**GS #323-024 ARPA INFR. – WASTE CENT. TREATMENT
SOUTH MISSISSIPPI CORRECTIONAL INSTITUTION
LEAKESVILLE, MISSISSIPPI**

ADDENDUM NO. 3
June 18, 2024

The Contract Documents for GS #323-024 ARPA INFR. –WASTE CENT. TREATMENT South Mississippi Correctional Institution Leakesville, Mississippi, are amended as follows:

Revisions:
Revisions:
PLAN VIEW - REQUIRED UV
DISINFECTION SYSTEM
C-701
Drawing Number

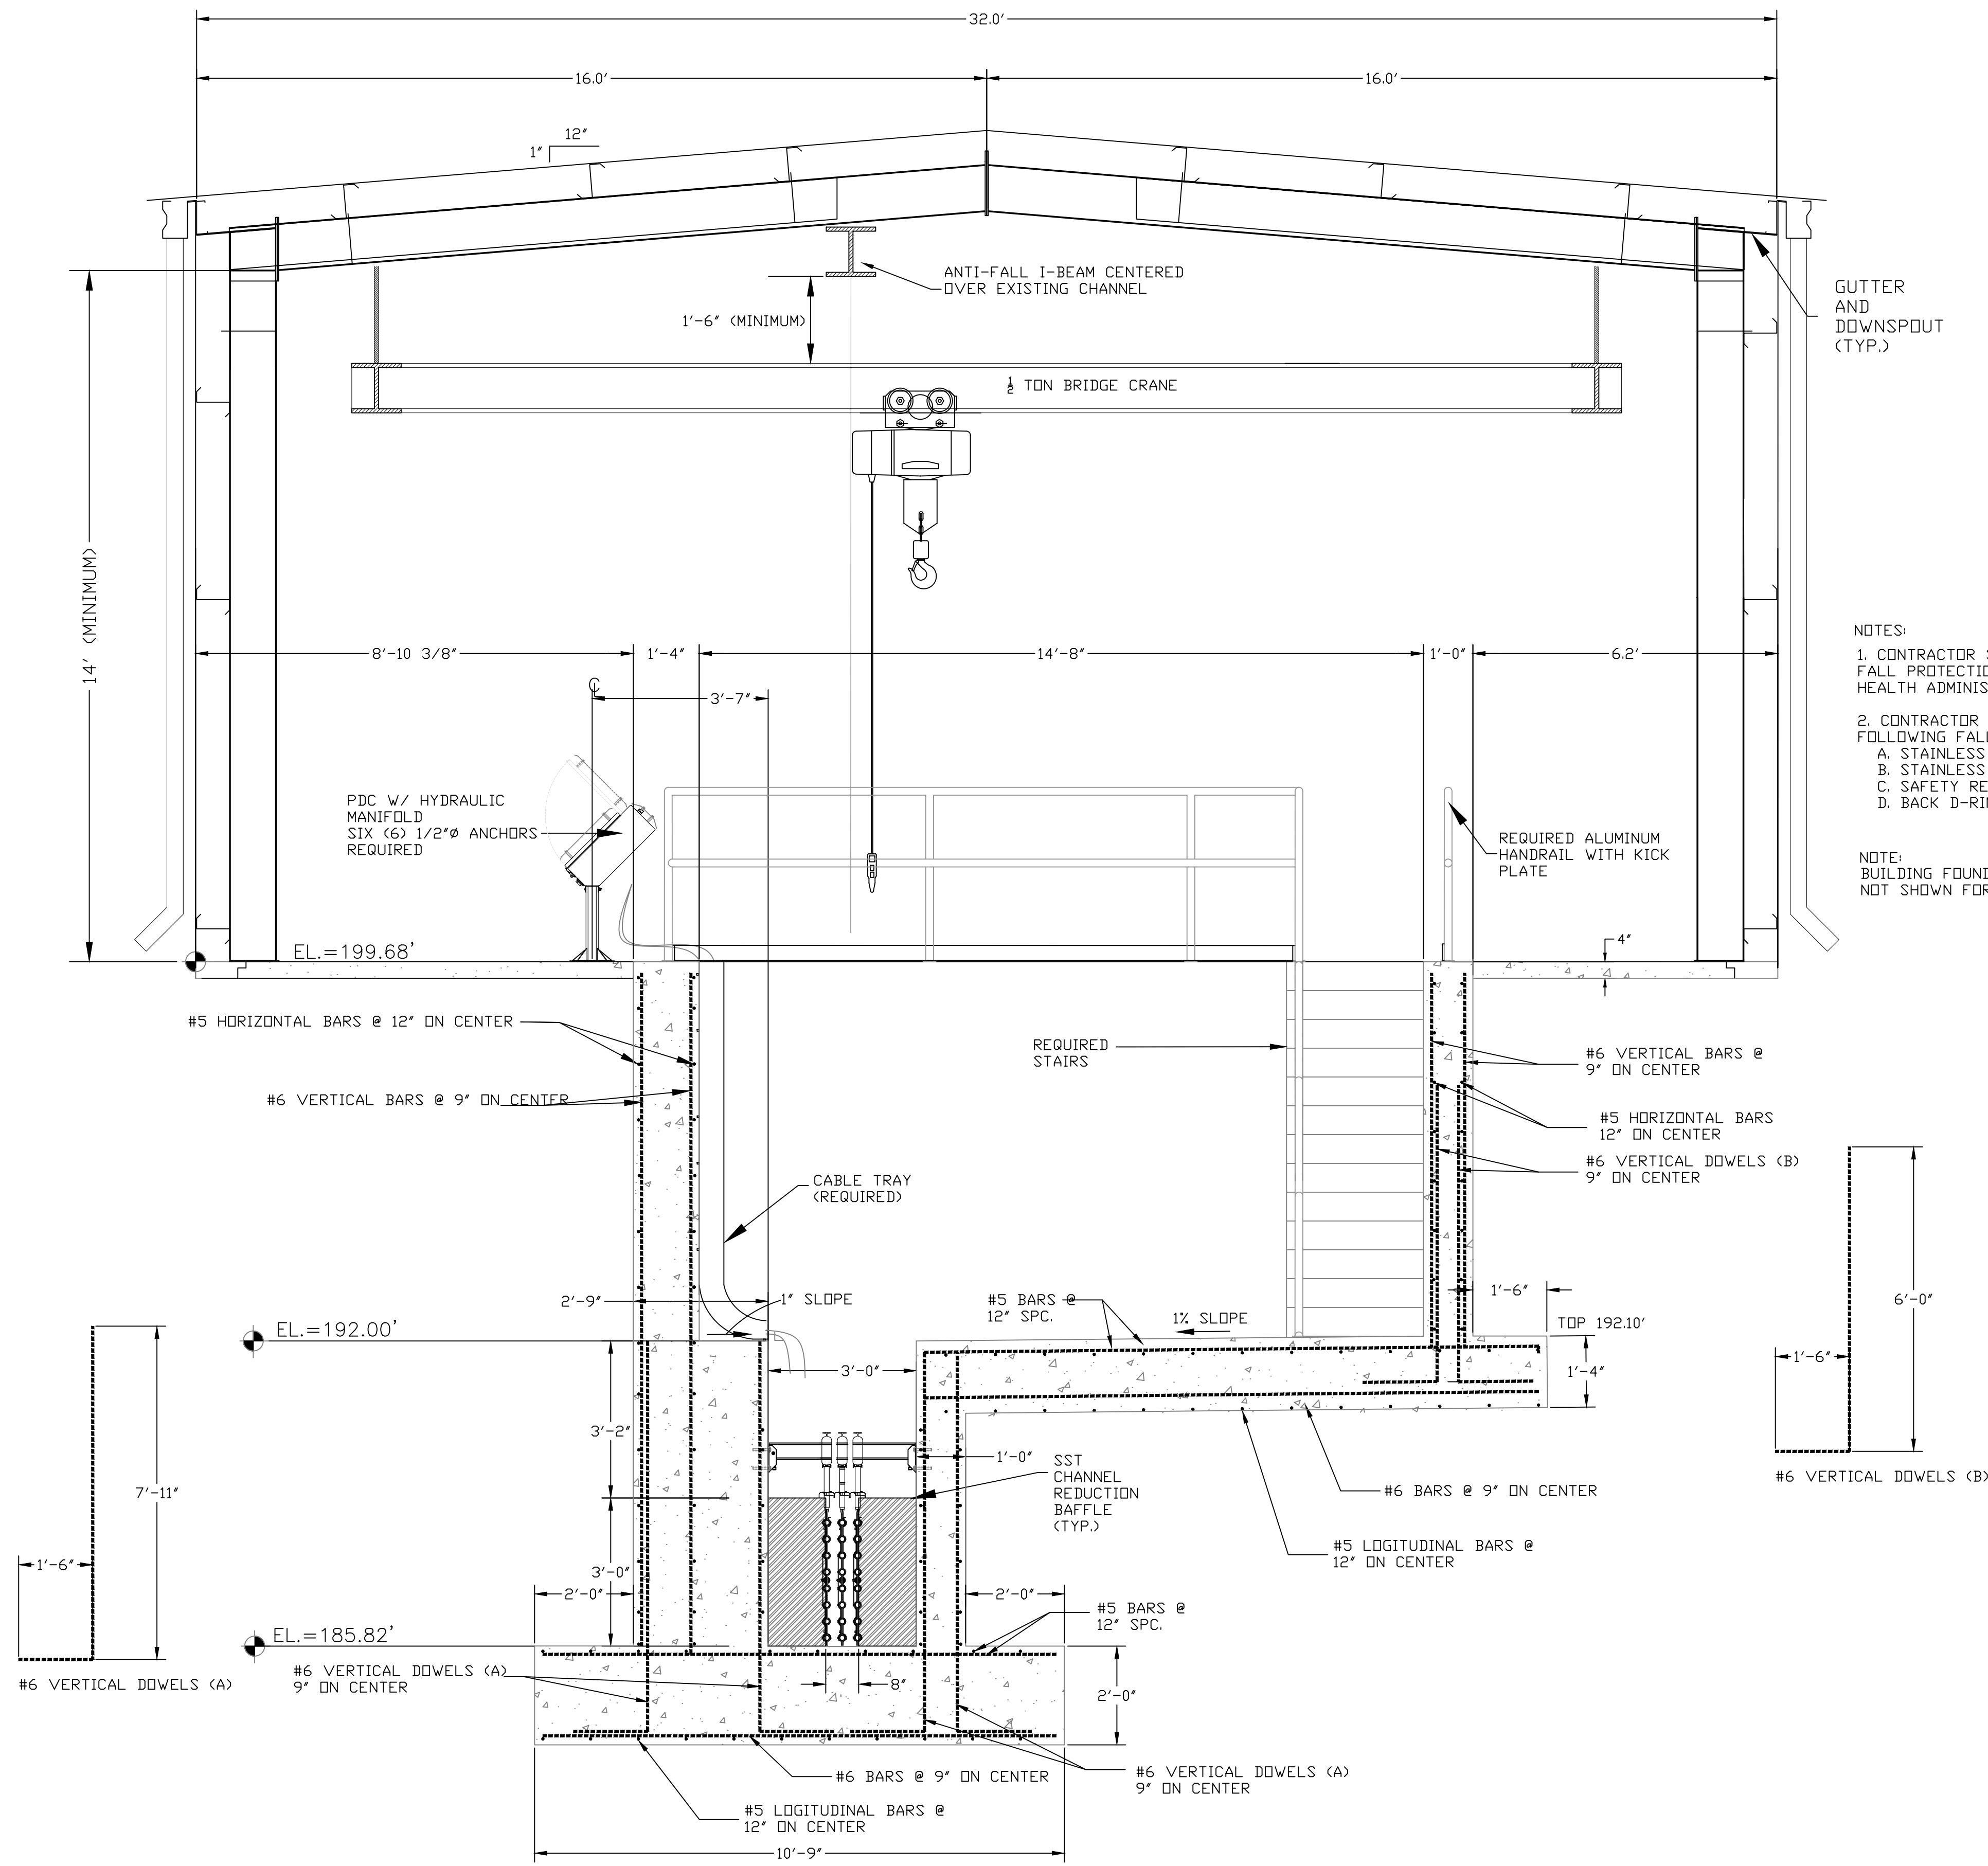
3. Replace the Measurement and Payment in toto with the enclosed Measurement and Payment.
4. The local control stations (LCS) shall be Class I, Division 1, Group D rated for the coarse screen, fine screen, and all pump stations. All enclosures shall be NEMA 4X rated, stainless steel.
